New Style Blower Motor

Front HVAC Assembly A22-60633-003

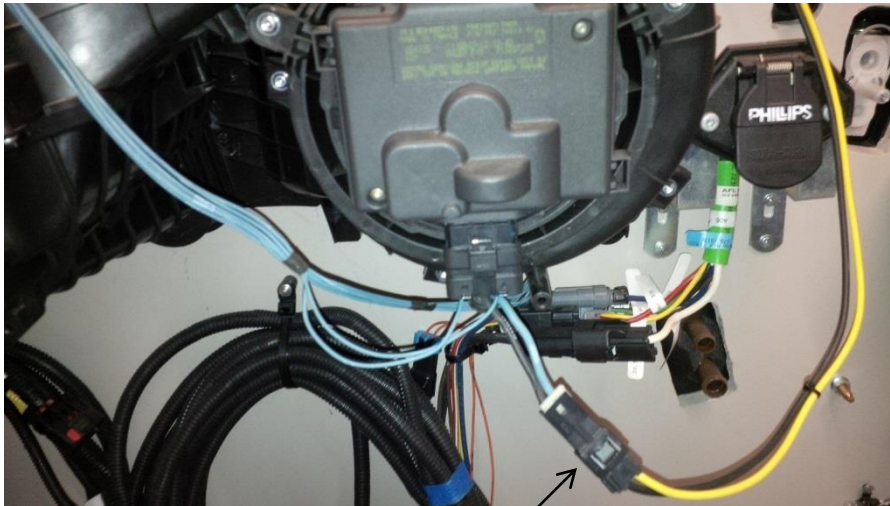
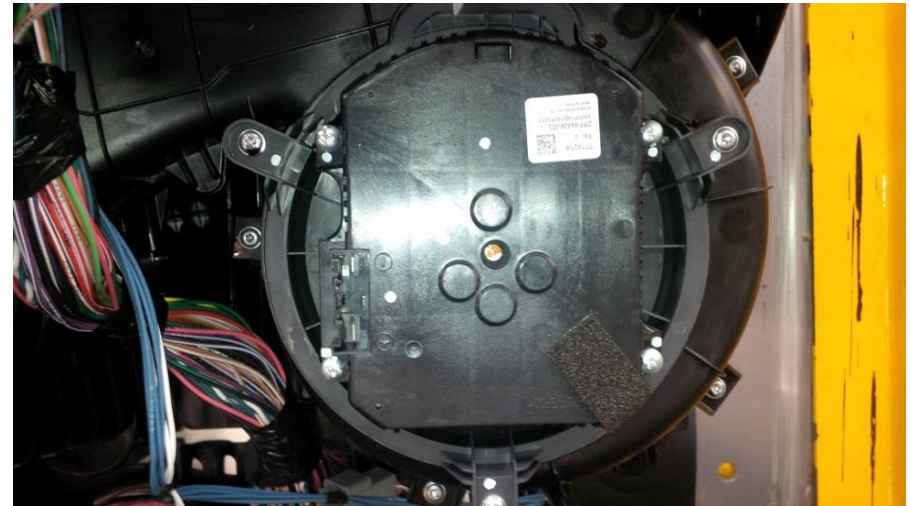
Old Style Blower Motor

Replacement of this connector

Old Brose Motor

New Shinano Motor

Shinano Blower Motor Connection

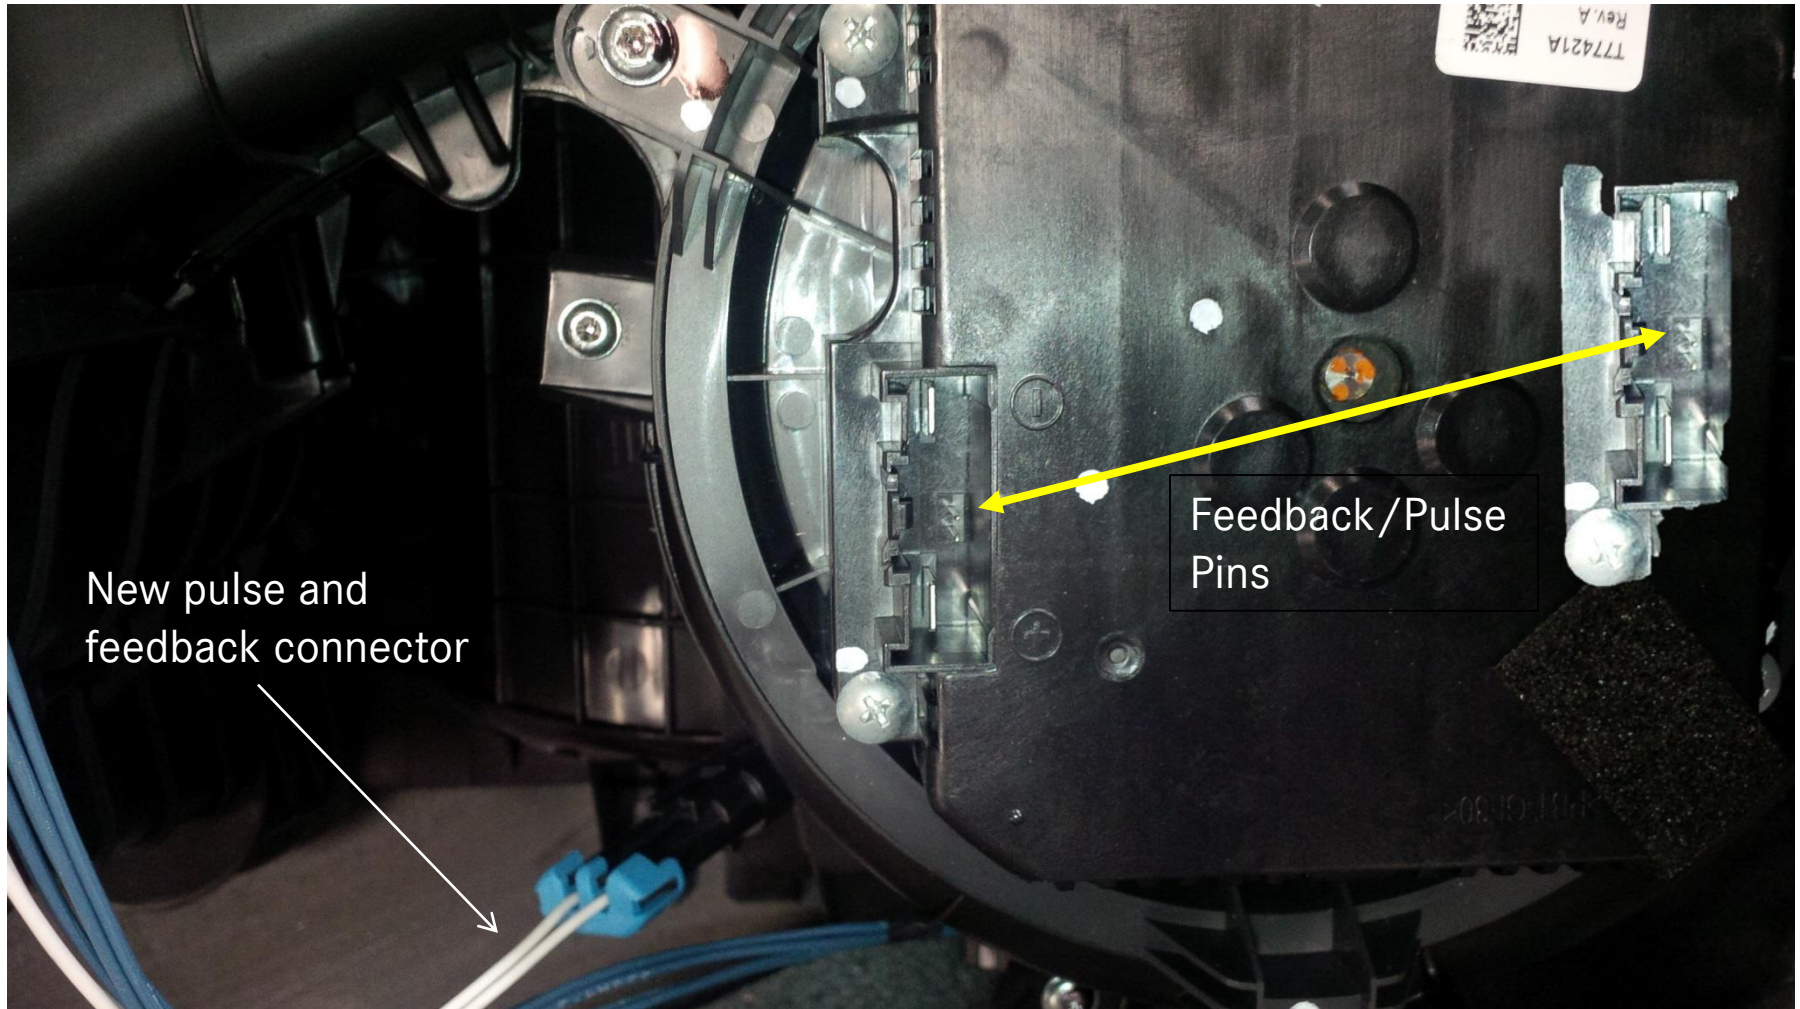
New pulse and feedback connector

Feedback/Pulse Pins

Full View

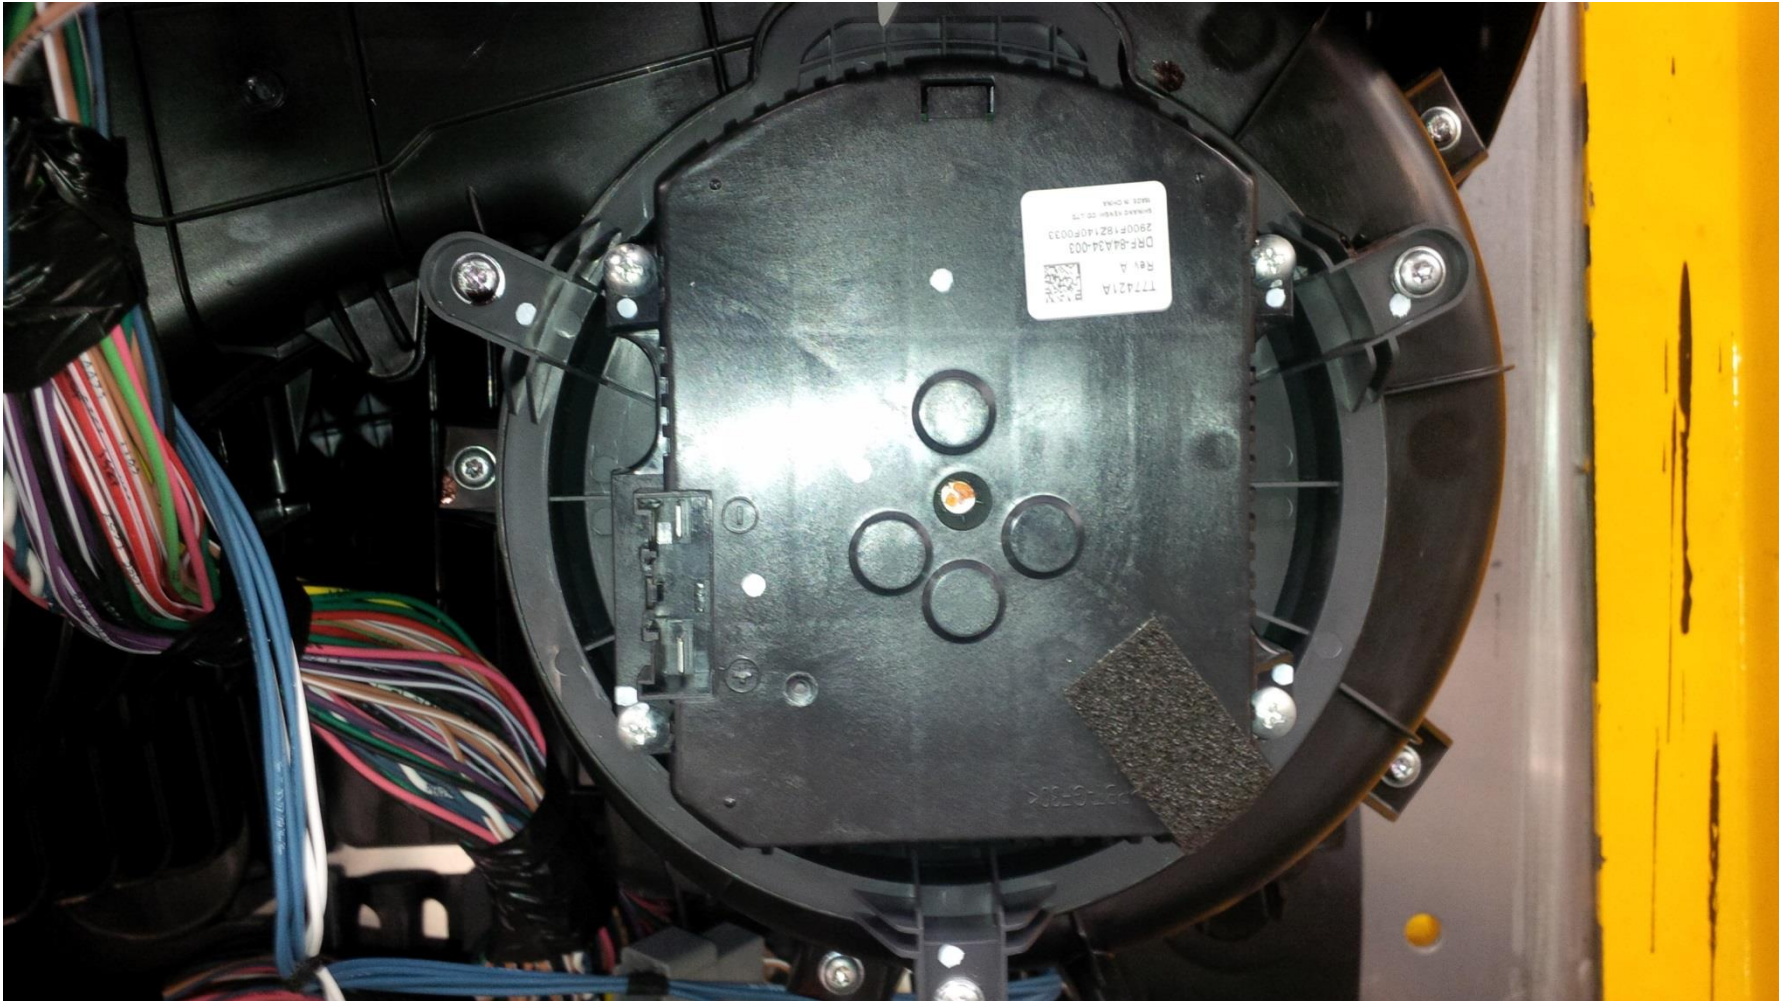
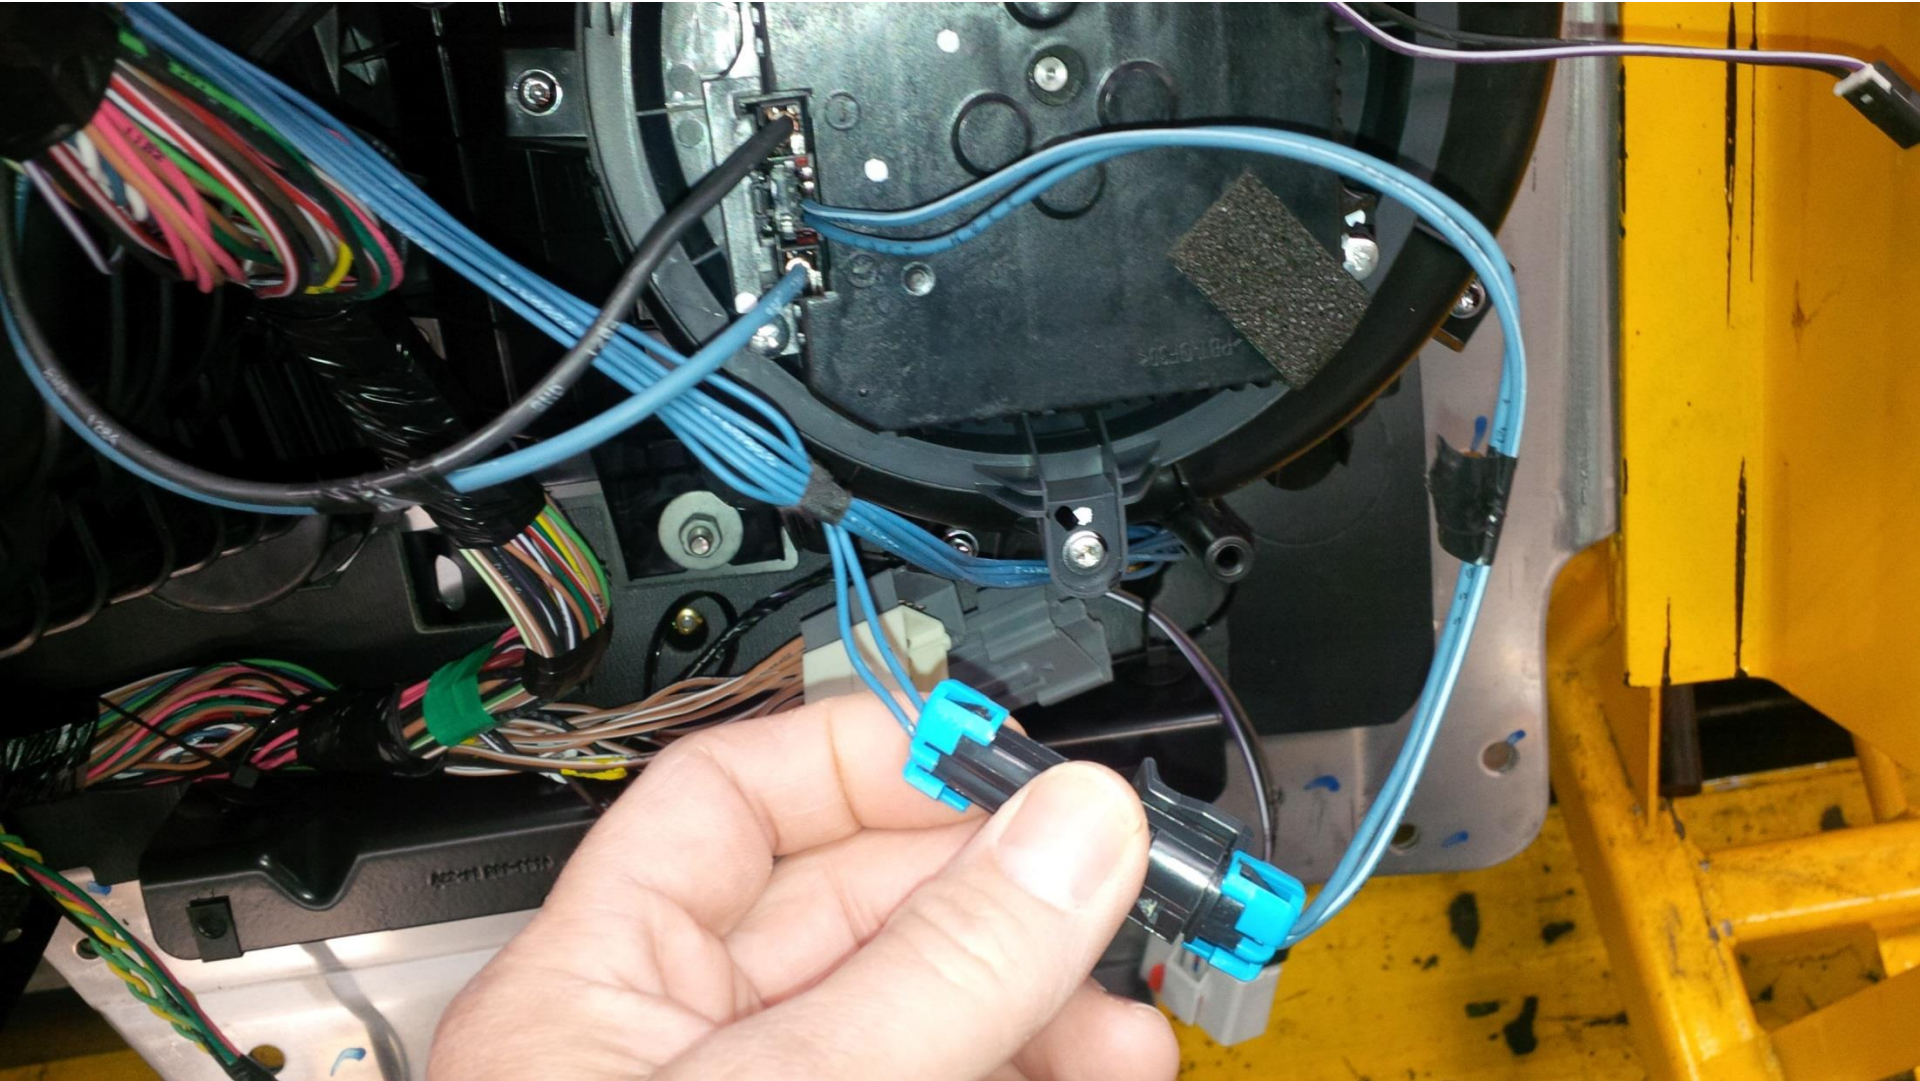
New Delphi 6 pin Connector
23-13662-605
